SVT
REV : 3B
2005-07-13

PROJECT : BV1
Quanta Computer Inc.

Revision History

BV1 / M-Note Schematic EC Tracking Record A (for DV --> SIV) Dec. 28, 2004**EC #/Page/Description/Part Affected/CMVC #**

Size Custom	Document Number ICH6 (2/3)	Rev 3A
Date: Wednesday, July 13, 2005	Sheet 17 of 72

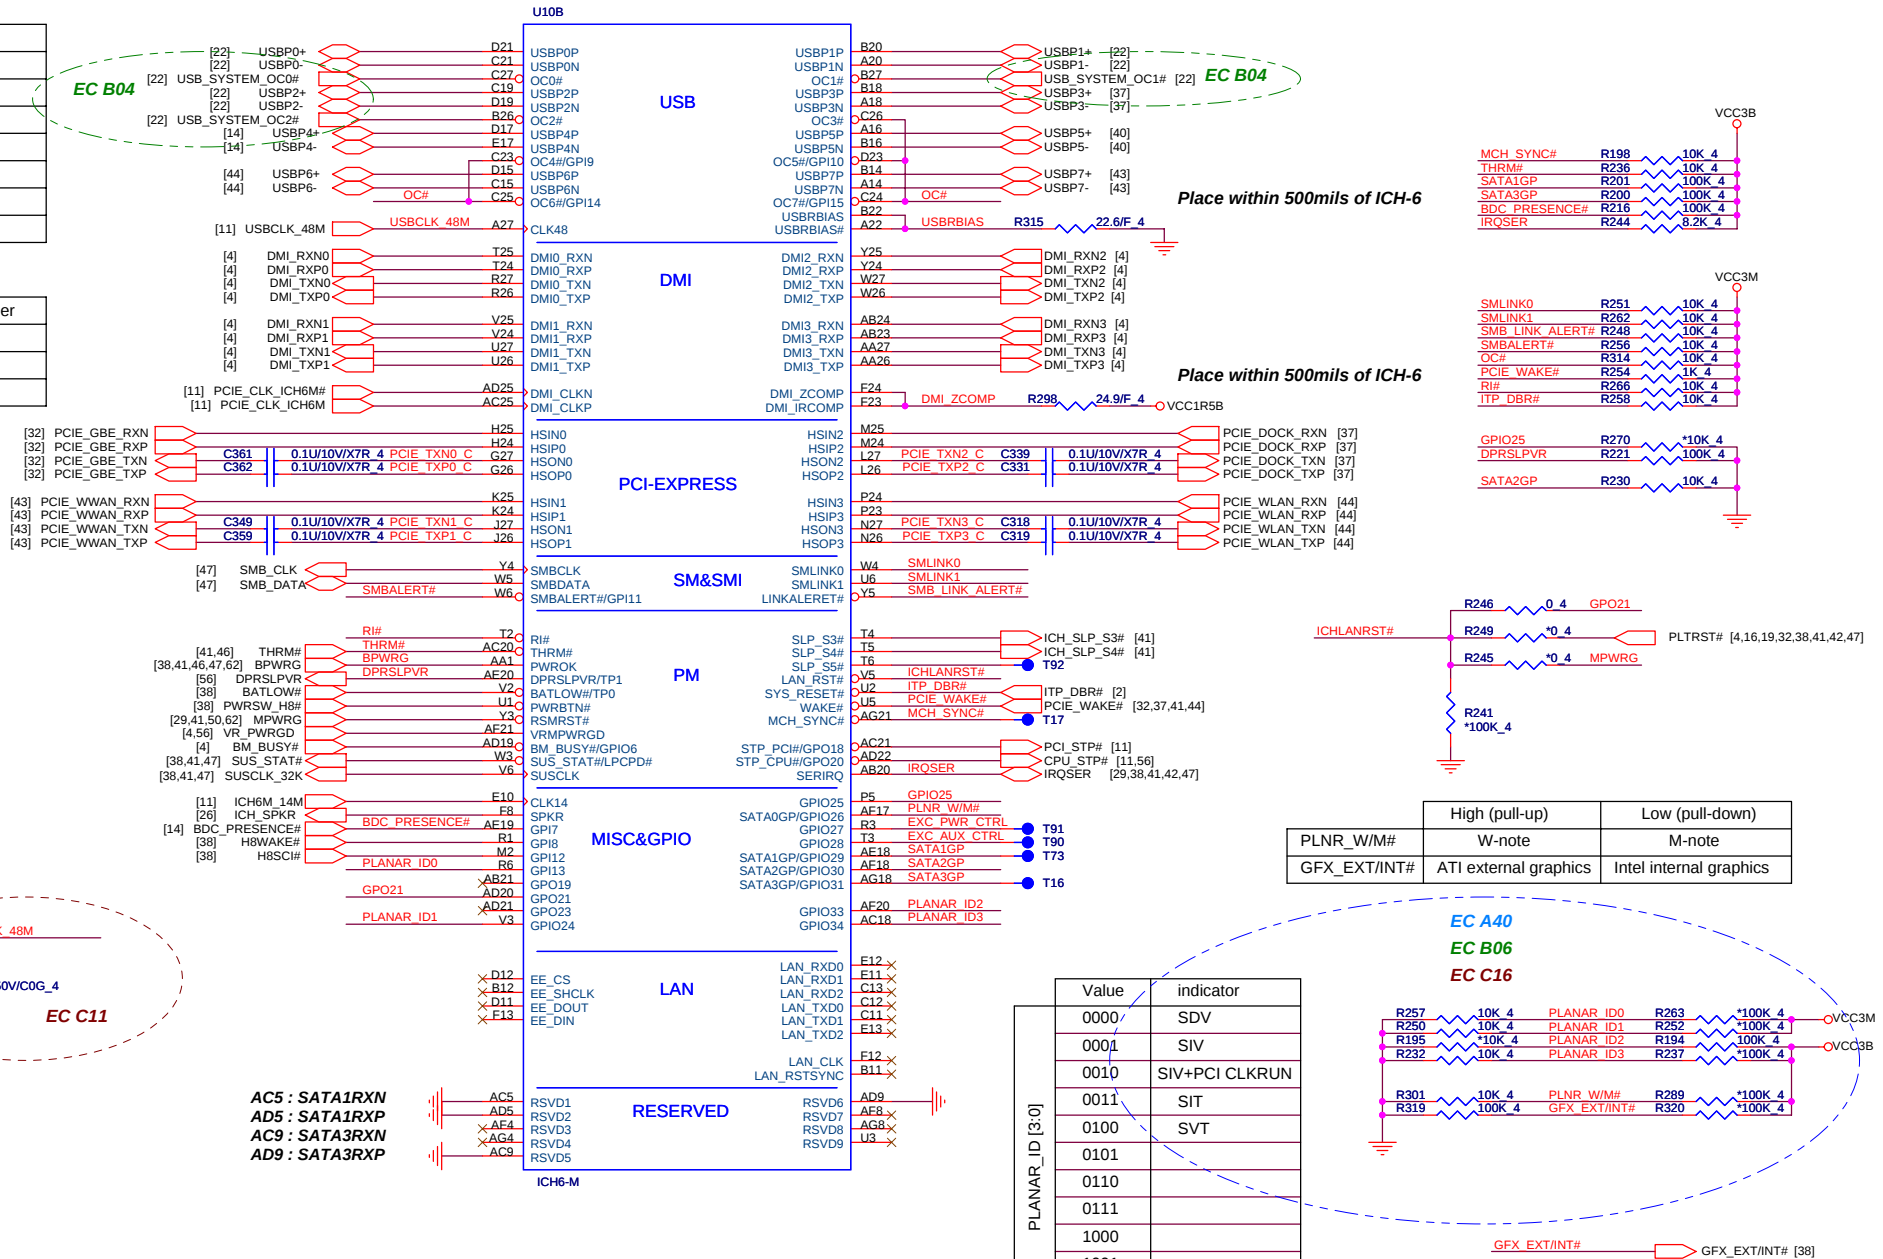
EC A40/17/ Change PlanarID [3..0] from 0000 to 0001. (SIV-IBM-11)

EC C13/50/ Change PU5 from MAX8724 to MAX8724A (SVT_IBM-14)
EC C14/55/ To reduce VCC5M undershoot.
EC C15/55/ To reduce VCC3M undershoot.
EC C16/17/ Planar ID change to SVT "4". (SVT_IBM-16)
EC C17/50/52/ Add cap according to EMI request.
EC C18/11/ Change PCICLK 33MHz damping for signal quality.
EC C19/23/ Pull down preparation (No ASM) on ACZ_RST# pin on code side (SVT_IBM-17)
EC C20/37/ Add ESD solution on PS/2 I/F
EC C21/37/ Reserve 0ohm resistor on FRAME# & PCICLK on debug connector for security concern (SVT-IBM-18)
EC C22/56/ Change PR193 & PR177 to ASM and value change to 10K
EC C23/11/ Change R352 value from 75ohm to 33ohm for USB 48MHz

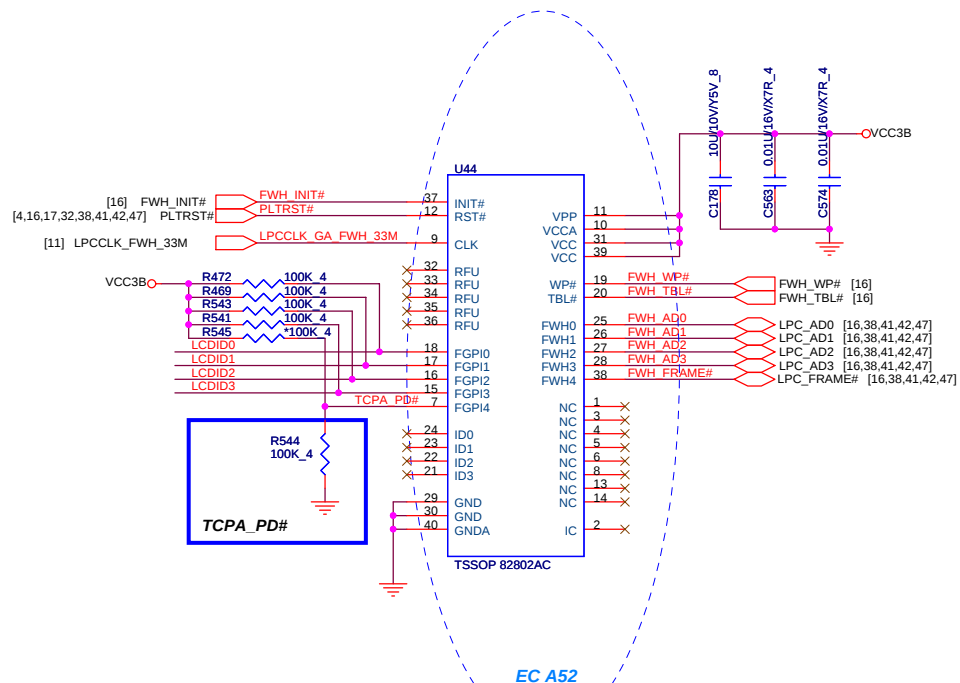
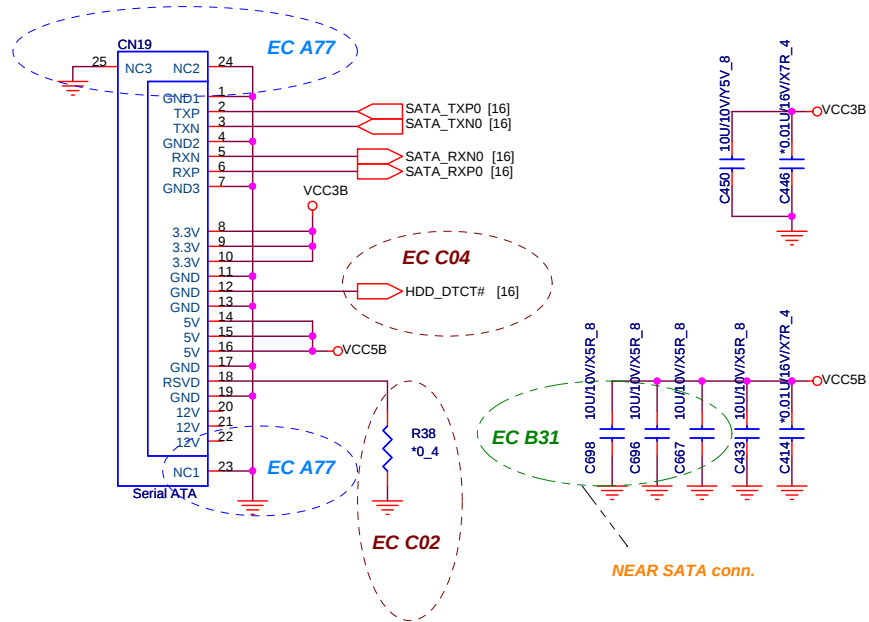
11/24 Change BT1 to be Tyco "1470366-2" and use cable-type coin battery

Size	Document Number	Rev
Custom	USB Ports	3A
Date:	Wednesday, July 13, 2005	Sheet 22 of 72

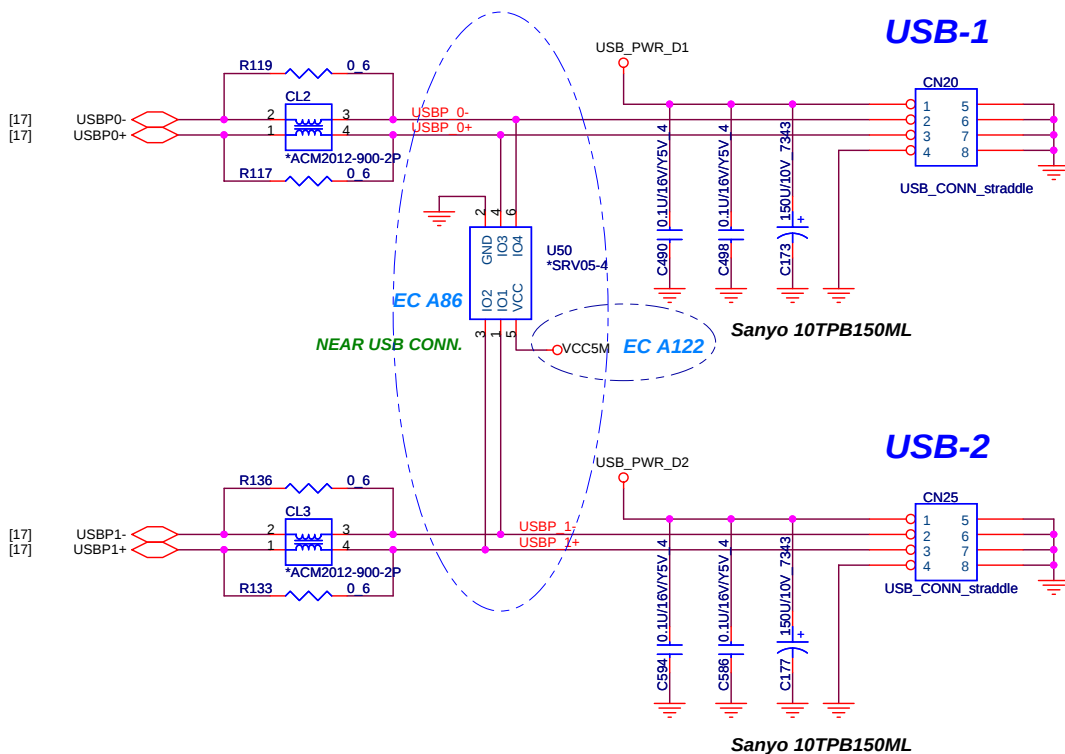
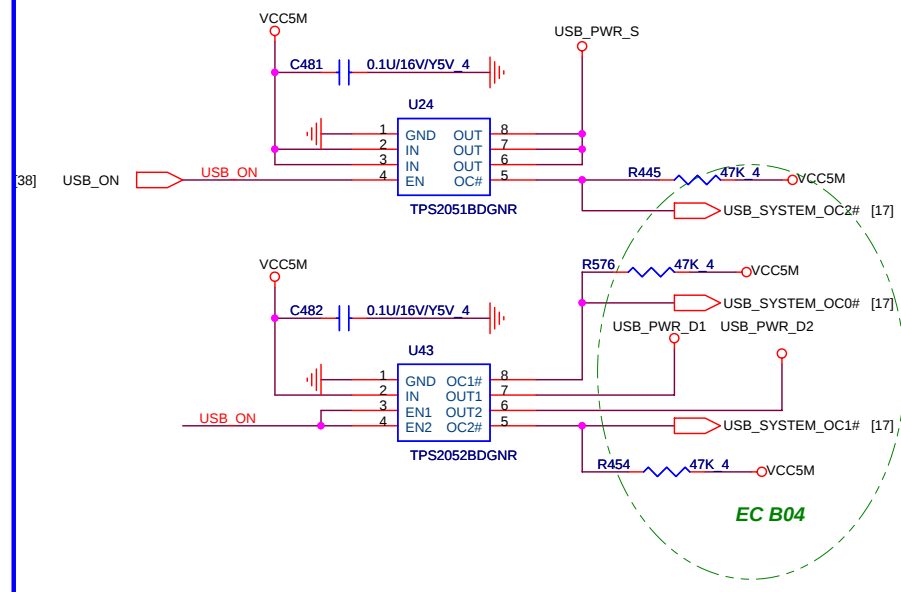
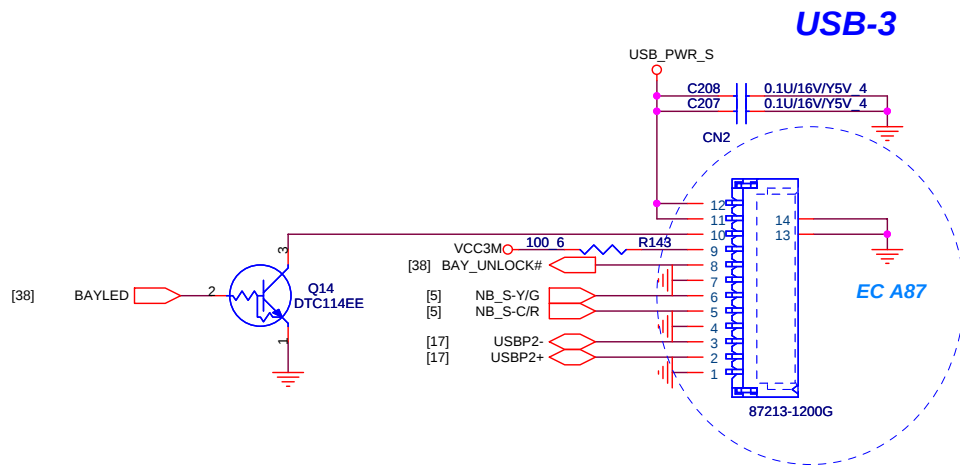
Change to TI solution (TPS2051 + TPS2052 power switch)
2004/12/09 Thunder

EC A122/22/ Change SRV05-4 pin5 to VCC5M. (SIV-IBM-49)
EC A123/50/ Change charge description.
EC A124/24,25/ Change R554,R573 to NOASM and R572 to ASM.
EC A125/40,47/ Change signal name SES_EN# to SES_EN.
EC A126/51/ Change PR107 from 470K to 75K ohm.
EC A127/14/ Change C212 from 0.047U/50V/X7R_6 to 0.1U/50V/X7R_6.
EC A128/61/ Change PU6 value from "MAX1589ETA-T to MAX1589ETT250+TW".
EC A129/55,56/ Change PC135,PC139,PC137,PC138,PC24,PC136,PC133,PC132,PC134,PC131,PC23,PC130,PC56 value from "ECPU1E105JBM" to "GRM31MR71E225KA93L".
EC A130/62/ Change PC115 to NOASM.
EC A131/37/ Change F3 to NANOSMDC050F.
EC A132/28/ Change R443 to 10 ohm.
EC A133/11/ Change R358, R84, R131, R132, R581 to 12.1 ohm 1%.
EC A134/35/ Change C666,C667 to NOASM for homologation.
EC A135/37/ Change R130 from NOASM to ASM.

Size	Document Number	Rev
Custom	AUDIO_HP_MIC	3A
Date:	Wednesday, July 13, 2005	Sheet 24 of 72

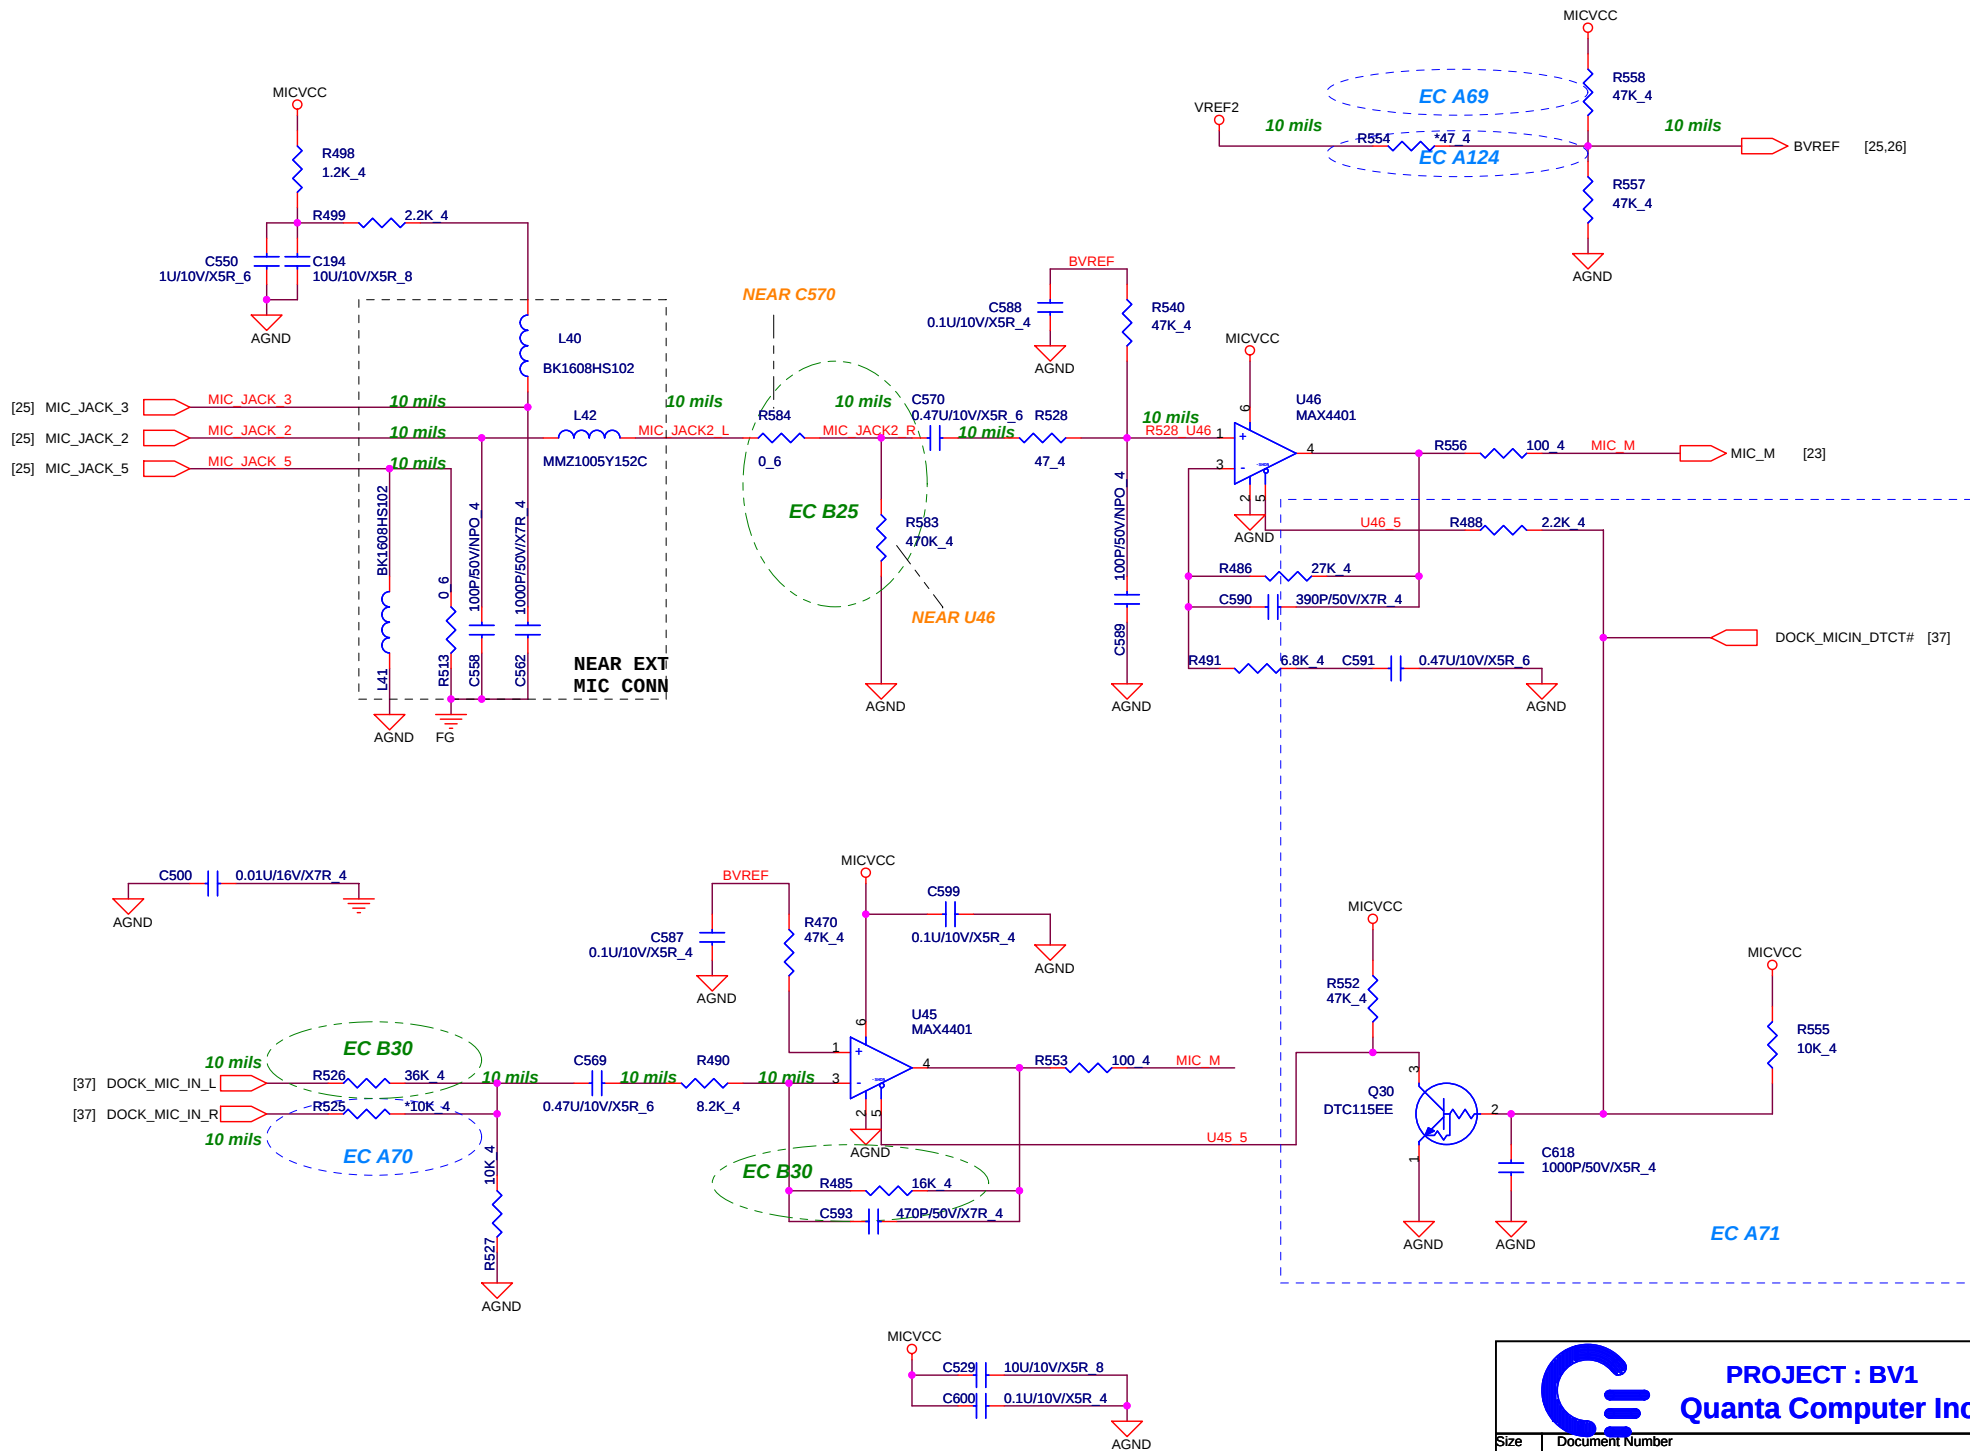
EC A66/32/ Change value of R247,R50,C299,C302 for IEEE lan measurement.
EC A67/08/ Add decouping capacitor of alviso power pin.
EC A68/25/ Change headphone selection circuit. (SIV-IBM-29)
EC A69/24/ Delete R555 pad. (SIV-IBM-23)
EC A70/24/ Change R525 to NO ASM. (SIV-IBM-23)
EC A71/24/ Change micphone selection circuit. (SIV-IBM-23)
EC A72/37/ Change net name from DOCK_MICIN_DTCT to DOCK_MICIN_DTCT# , DOCK_HPOUT_DTCT to DOCK_HPOUT_DTCT#. (SIV-IBM-29)
EC A73/23/ Change +EQ_BYPASS circuit. (SIV-IBM-23)
EC A74/23/ Add stereo external microphone circuit. (SIV-IBM-23)
EC A75/31/ Delete ESD lan switch diode.
EC A76/23/ Delete R130 pad.
EC A77/20/ Alignment guide pin of SATA HDD connector should be soldered to GND pad (SIV-IBM-30)
EC A78/35/ Add ESD TVD diode (SRV05-4) NO ASM near RJ45 connector side. (SIV-IBM-28)
EC A79/38/ Change H8 charge circuit. (SIV-IBM-31)
EC A80/38/ Keep CHARGE_CELL0 , CHARGE_CELL1 pull high resistor.

EC B16/14/ Change Q16 FET from SI3424DV to SI4890DY. (SIT-IBM-22)
EC B17/50/ Change for AC Adapter polarity Test Fail. (SIT-IBM-26)
EC B18/38/ Change GPIO_BT Pull up to Pull down. (SIT-IBM-27)
EC B19/50/ Change PQ46 from SI4890DY to SI4840DY. (SIT-IBM-26)
EC B20/35/ Change CN7 connector of pin3,4 to non ground pin for safety Hi-port test.
EC B21/35/ Remove C666,C667 pad.
EC B22/48/ Add 10uF/10V capacitor for VCC5B voltage drop while FAN turn on.
EC B23/19/ Reserve R,C for EMI request.
EC B24/14/ Change F4 to 1206 footprint.
EC B26/56/ Add NO ASM capacitors " GRM21BR71E155K" in VINT19 power rail to prevent any issue may happen like Voltage Dip on VINT19 or LCD Flicker or Acoustic Noise etc... (SIT-IBM-32)
EC B27/50/38/62/52/ Support 65W AC adapter. (SIT-IBM-33)
EC B28/53/ Chagne PR220,PR215 from 5.62K/F to 6.04K/F. (SIT-IBM-34)
EC B29/50/ Chagne PR96 from 470K 5% to 220K 5%. (SIT-IBM-35)
EC B30/24/ Chagne R526 from 10K 5% to 36K 5% ; R485 from 8.2K 5% to 16K 5%. (SIT-IBM-36)
